Hi-Fi Products Service Bulletin

Model: TC-K700ES

No. 7

Subject: Improvement of Wow and Flutter

【System Control Board】

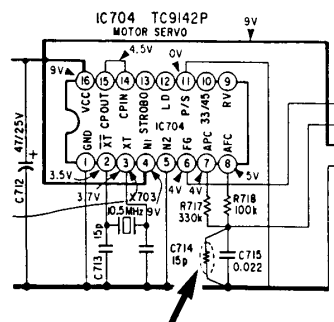
Wow and flutter is generated just after play is initiated.

Add an 820K Ω resistor (P/N 1-215-491-00) in parallel with C715 on the system control board.

Mount a 820K Ω resistor here
